LOWER LOS ANGELES RIVER  
WATERSHED COMMITTEE

**SUBJECT: Implementation of Lower Los Angeles River CIMP: Request to Move One Monitoring Site from the Cerritos Pump Station to the Hill Street Pump Station for Technical Reasons**

## **CERRITOS PUMP STATION AND CONSIDERATIONS OF AN ALTERNATIVE MONITORING SITE**

**Figure 1. Cerritos Pump Station and Large Gravity Outfalls Just to the South**

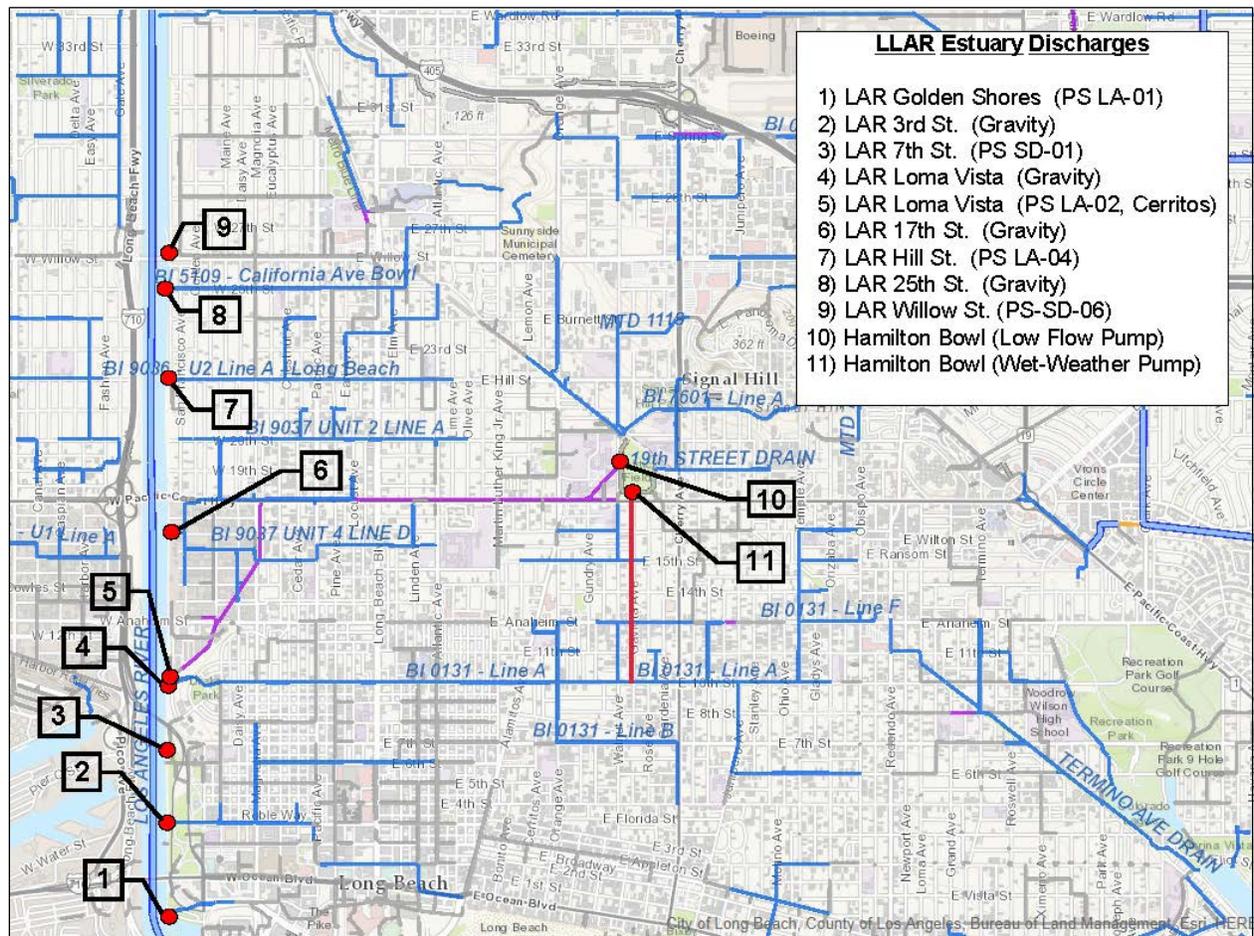
An overview of the Cerritos Pump Station is shown in Figure 1 below. Though aligned with four large outfalls to the river, the pump station actually discharges from the Hamilton Bowl through an outfall just above these large gravity outfalls. The large outfalls just to the south are gravity outfalls originating from the City of Long Beach area on the bluff above, but with a 78-inch connection to the Hamilton Bowl (Figure 2).

The first consideration of an alternative monitoring site was the large nearby gravity drain that flows to the river at the site of the Cerritos Pump Station (Figures 1 and 2). This drain consists of four, 78-inch outflow pipes that discharge to the Los Angeles River and drains a large area of Long Beach east as far as Redondo Blvd and below the Pacific Coast Highway, though intermingled with the City drainages. It also includes a 78-inch drain that flows south from the Hamilton Bowl underneath Gaviota Avenue down to this drain line in Long Beach. However, at the River this large gravity drain has an elevation equal to the invert of the Los Angeles River channel in this estuarine area of the River and thus is subject to significant estuarine water intrusion far up these conveyances. The outfall pipes pass under the old rail tracks and converge to a large underground dome drainage channel that persists way under (35 feet below ground level) the land and bluff to the east. Sampling access to this large underground conveyance was found in Drake Park immediately above on the bluff, but instrumentation of this large, deep underground drain is not feasible given its depth, salt water intrusion problems, and crew safety issues.

**Figure 2. Overview of Eastern Drainages to the Lower Los Angeles River Estuary**

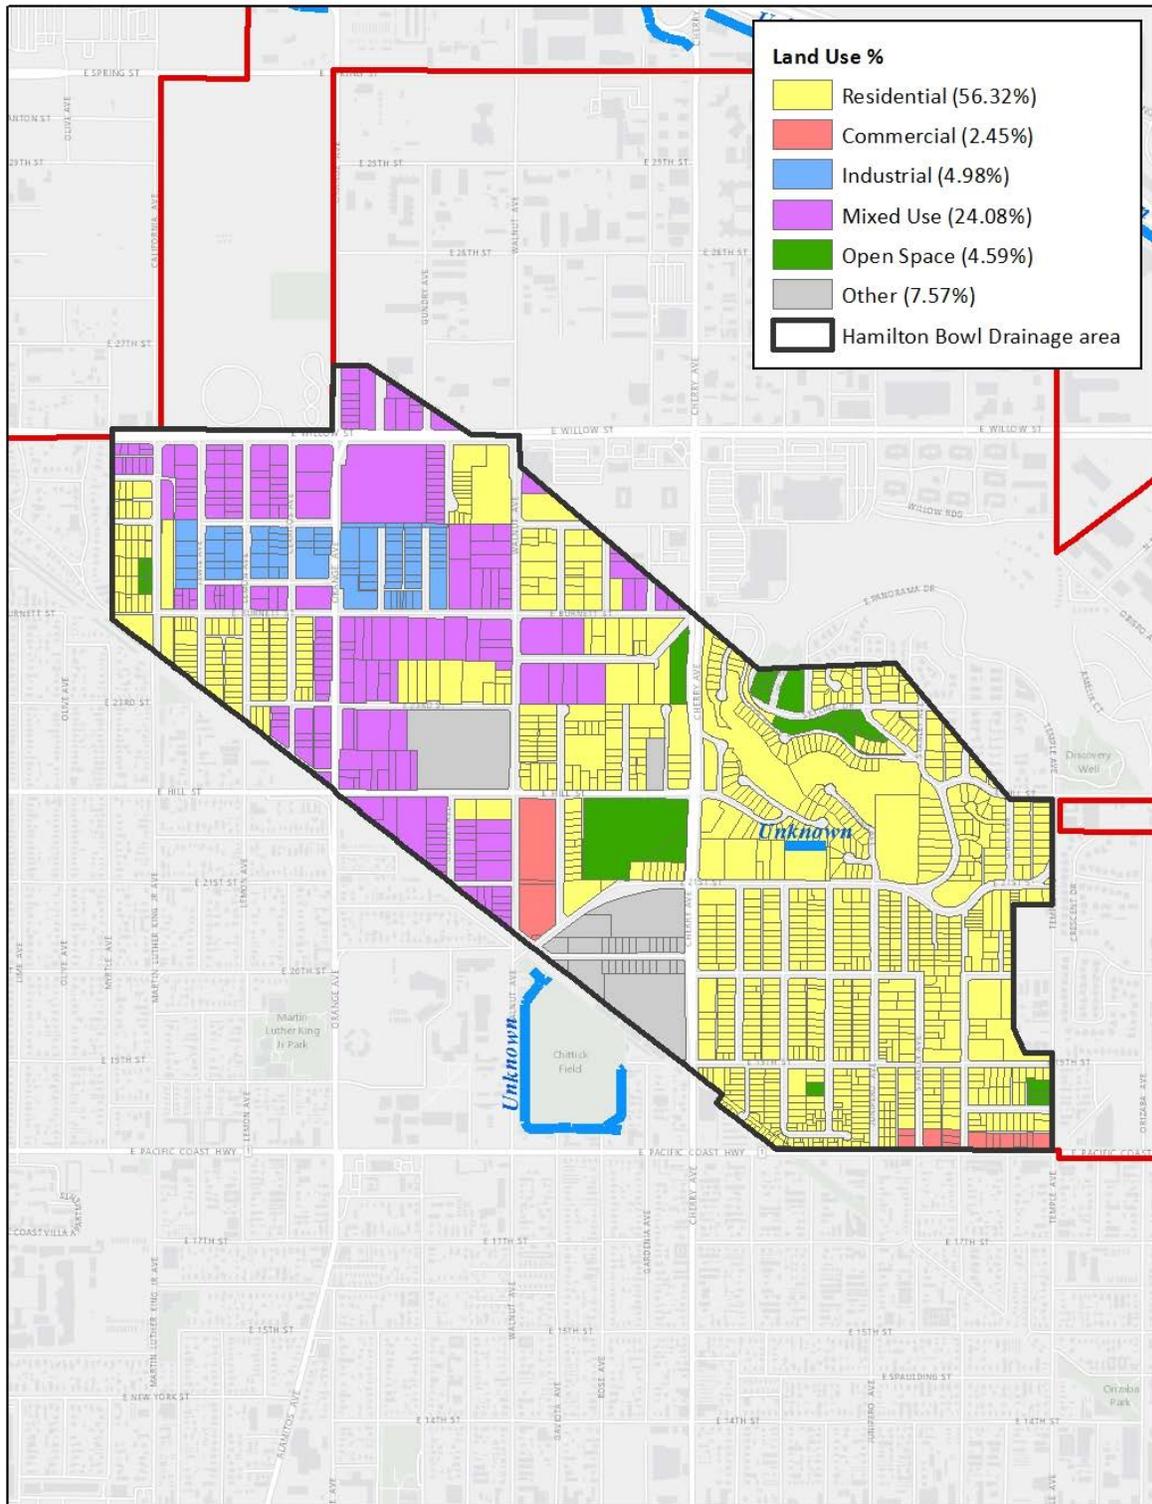
The line from the Hamilton Bowl low flow pump that discharges to the Cerritos Pump Station is shown above in Figure 2. The second line from the main Hamilton Bowl discharge pumps for wet weather goes to the south through a 78 inch line to Line A, which discharges at the gravity drain to the river located just below the Cerritos Pump Station (Figure 2). The Hamilton Bowl collects water from above in Signal Hill (Figure 3).

Also shown in Figure 2 are drainages to the Lower Los Angeles River estuarine area that were investigated to find an alternative monitoring site for the Lower Los Angeles River CIMP.

**LAR 7<sup>th</sup> Street Pump Station (PS-SD-01).** This 7<sup>th</sup> Street Pump Station drains a very small area under the freeway interchange (Figure 2). It has two intakes flowing separately into the sump which would require instrumentation of all pumps or of each drain. Since the land use in this drainage area is not being targeted and because of the increased difficulty of instrumenting this station, the 7<sup>th</sup> Street Pump Station was rejected as a CIMP monitoring site.

**LAR 3<sup>rd</sup> Street Gravity Drain.** This gravity discharge from the west bank to the Los Angeles River Estuary is from a drainage in the City of Long Beach west of Atlantic possibly intermingled with City lines (Figure 2). The invert at the River allows saline water to intrude up the discharge pipe, and the conduit up on the bluff is deep. For these reasons, this gravity drain was not chosen for a CIMP monitoring site.

**Golden Shores Pump Station (PS-LA-01).** This pump station is located at the very end of the Los Angeles River where it enters the Port (Figure 2). This pump station drains an area below the Ocean Boulevard bluff. Previous investigations carried out at this pump station and in the upstream drainage as part of possible diversion studies showed the discharges to be highly saline (~19 ppt) due to ground water and dewatering sources. Thus, this pump station was rejected as a CIMP monitoring site.

**Figure 5. Hill Street Pump Station**

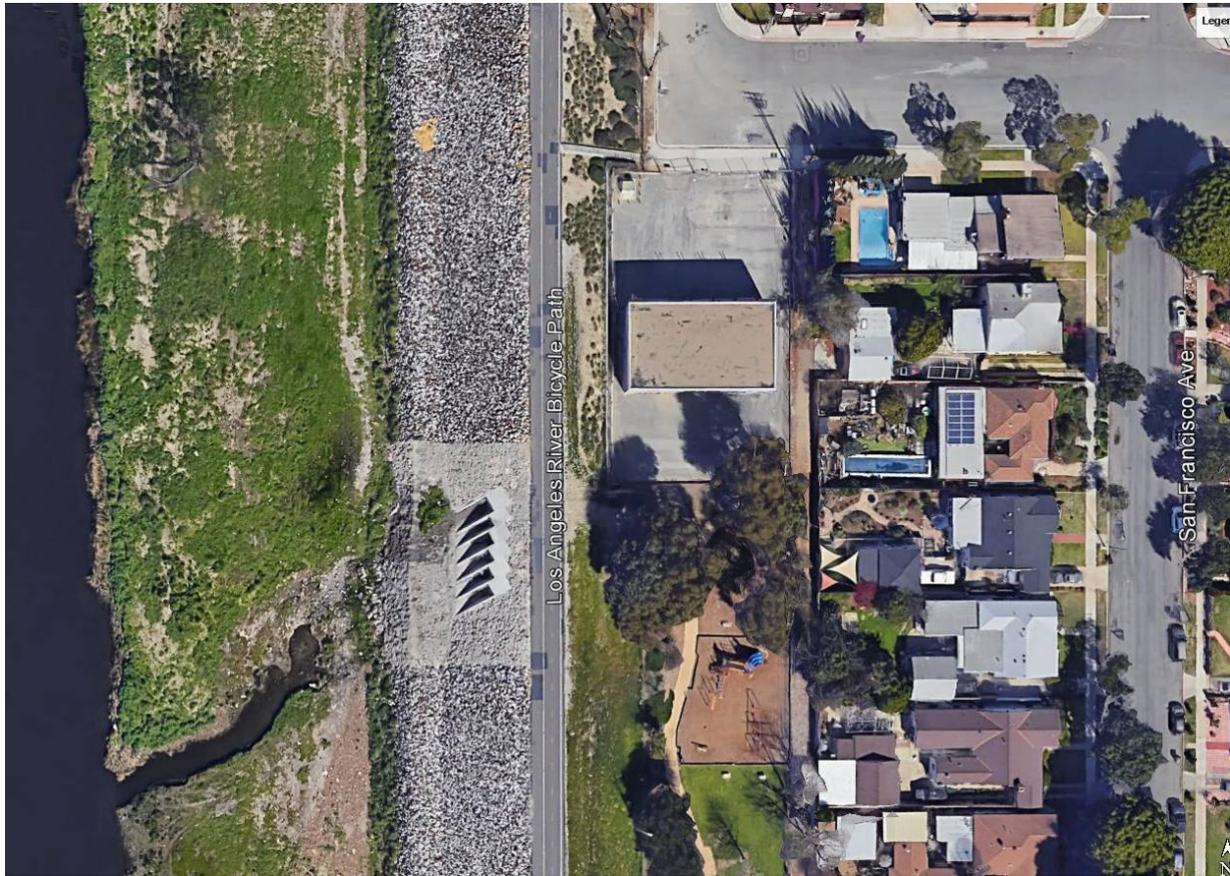
**Hill Street Pump Station.** The Hill Street Pump Station has one large underground intake conduit located under a quiet side street and accessible through a drop inlet. The instrumentation box can be placed curbside. Thus, this site was selected for further examination. This pump station has four large diesel pumps, two electric pumps, plus a summer pump.

The Hill Street Pump Station discharges at the east bank of the Lower Los Angeles River from a drainage area on the west side of Long Beach (Figures 2 and 5). Drainage is from the area south of Willow Street, west of Lime Avenue, and north of Hill Street. The Hill Street Pump Station has a drainage area (Figure 6) of 366 acres.

## **5.0 Selection of Hill Street Pump Station as Alternate to the Cerritos Pump Station for LLAR CIMP Monitoring**
